Office Action Communication		A	pplication No.	Applicant(s)	Applicant(s)			
		,	10/539,996	ZHANG, YUQI	ZHANG, YUQI			
Office Action Summary			xaminer	Art Unit				
		В	RYAN R. MULLER	3727				
Period fo	The MAILING DATE of this commu or Reply	nication appear	rs on the cover sheet	with the correspondence a	ddress			
WHIC - Exter after - If NC - Failu Any	ORTENED STATUTORY PERIOD FOR CHEVER IS LONGER, FROM THE IN THE INSIGN SOLVEN THE INS	MAILING DATI s of 37 CFR 1.136(a munication. tatutory period will a y will, by statute, cau	E OF THIS COMMUN.). In no event, however, may apply and will expire SIX (6) MO use the application to become	IICATION.  a reply be timely filed  DNTHS from the mailing date of this ABANDONED (35 U.S.C. § 133).	•			
Status

#### **DETAILED ACTION**

Fig. X (from Fig. 1 of Xu)

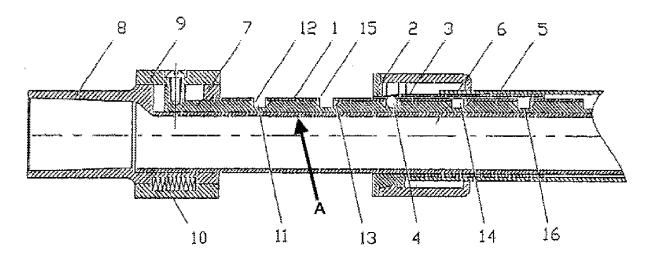
penetrate through the wall of the inner pipe from said outer surface to said inner surface or that the inner pipe has a separate inner liner layer fixed to the inner surface for isolating vacuum of the inner pipe from the detent holes. Xu discloses a similar telescopic suction tube for a vacuum cleaner having inner and outer pipes and a locking device to lock the inner and outer pipes in position relative to one another and Xu further discloses an actuating mechanism for moving the locking device from a locking state to an unlocking state by an actuating element (9) that is located at an end of the inner pipe that is distal from the outer pipe. Xu discloses several embodiments including a third embodiment (Fig. 5) wherein a rack (1) including detent holes (11) is formed as part of the inner pipe (6), the detent holes penetrating through the rack of the inner pipe from an outer surface to an inner surface and the inner pipe (6) having a separate inner liner wall (A in Figs. X and Y below) that is secured in a fixed position to the inner surface of the inner pipe (6) by collar (8) and will isolate the vacuum of the inner pipe from the rack and the detent holes wherein a control rod (7) for moving locking member (4) into or out of a locked position is slidably disposed between the rack of the inner tube and the inner liner wall for controlling the locking mechanism. Therefore, it would have been obvious to one of ordinary skill in the art at the time the invention was made to provide the suction tube of Zhang with a similar actuating mechanism, as taught by Xu, to allow a user to alternatively move the locking device from a locking state to an unlocking state to move the inner and outer pipes relative to one another either by engaging the locking device (4-7) of Zhang on the outer pipe or by engaging the actuating element (9) of Xu on the end of the inner pipe, which will allow a

user to adjust the length of the suction tube by whichever mechanism is more convenient during use when starting or finishing use of the suction tube. Therefore, it would have been obvious to one of ordinary skill in the art the detent holes of Zhang to pass through the wall of the inner pipe to allow the detent pin to engage corresponding openings (12) of the control rod (7) and to provide the inner pipe of Zhang with a separate inner liner layer (similar to A below) that is fixed to the inner surface thereof and will obviously isolate vacuum pressure of the inner pipe from the detent holes and allow the control rod (7) to be slidably positioned between the rack of the inner pipe and the inner liner layer.
